# UNITED STATES PATENT AND TRADEMARK OFFICE

APPLICATION NO.	FILING DATE	FIRST NAMED INVENTOR	ATTORNEY DOCKET NO.	CONFIRMATION NO.
10/017,924	12/07/2001	Hsin-Hong Huang	10541/775	1505

**Office Action Summary**

## **DETAILED ACTION**

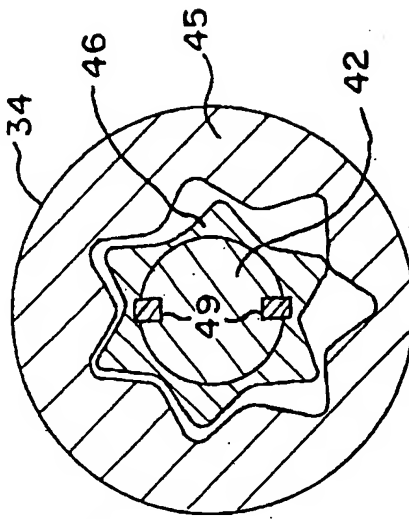
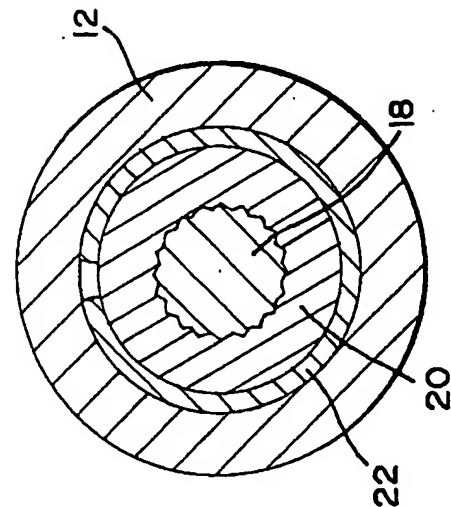
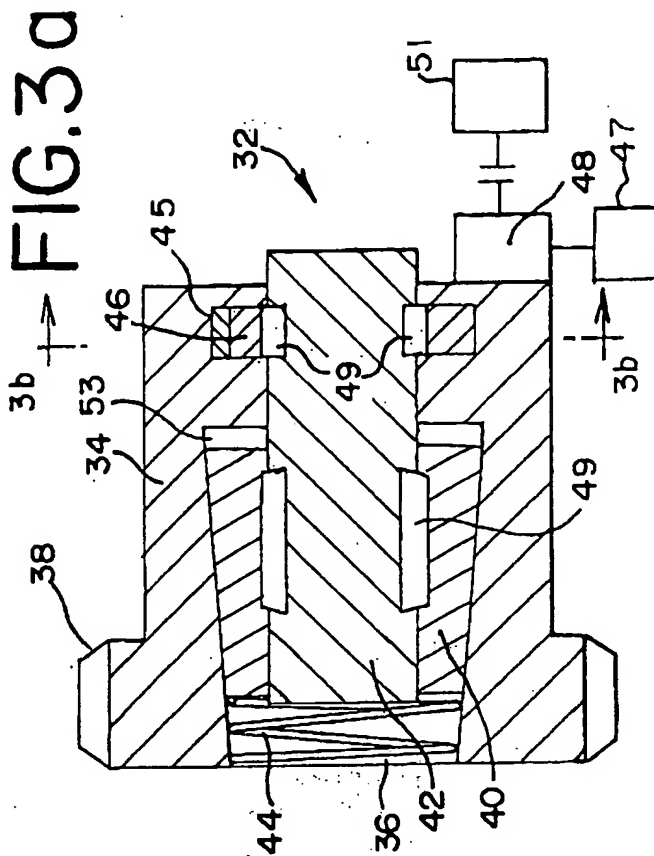
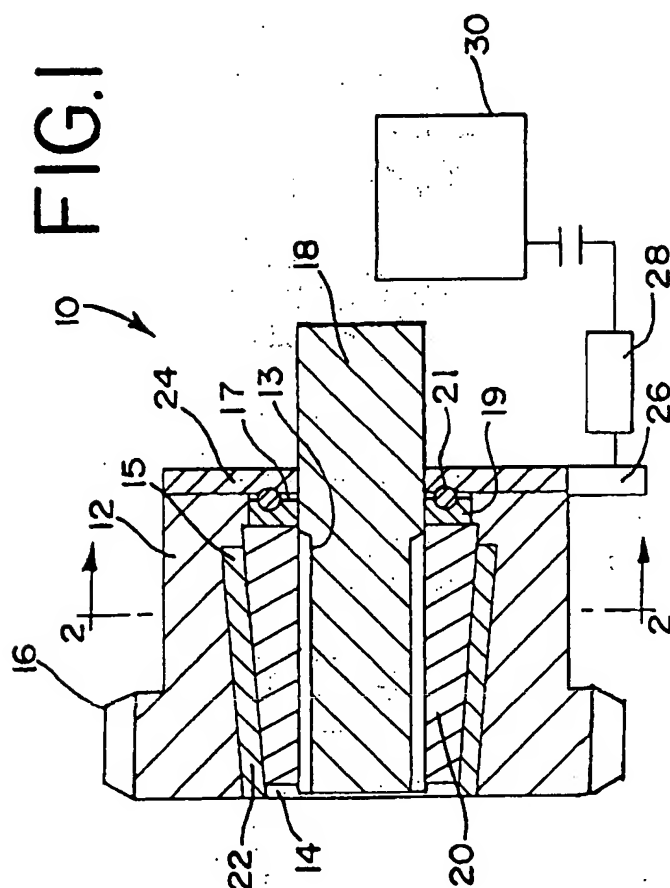
The drawings were received on 7/7/03. These drawings are not acceptable for the reasons below.

The drawings are objected to because the first sheet of the two sheets submitted as corrected sheets contain different figures unrelated to the invention originally submitted to the Office (see attachment). Reference character 30 in Figure 5 should be deleted since 30 does not point directly to a polygonal surface as shown in Figure 2, and the polygonal surface of Figure 2 and Figure 5 are distinct parts and not the same part. Furthermore, the axis 25 is still not aligned from the left side to the right side of 24. Applicant is urged to use a straight edge to confirm this discrepancy. The lead line of reference 40 appears to point to the driven member 24 in Fig. 4. Reference character 24 in Figure 4 should be arrowed as it appears to point to the gear 26.

not accepted  
10/6/03
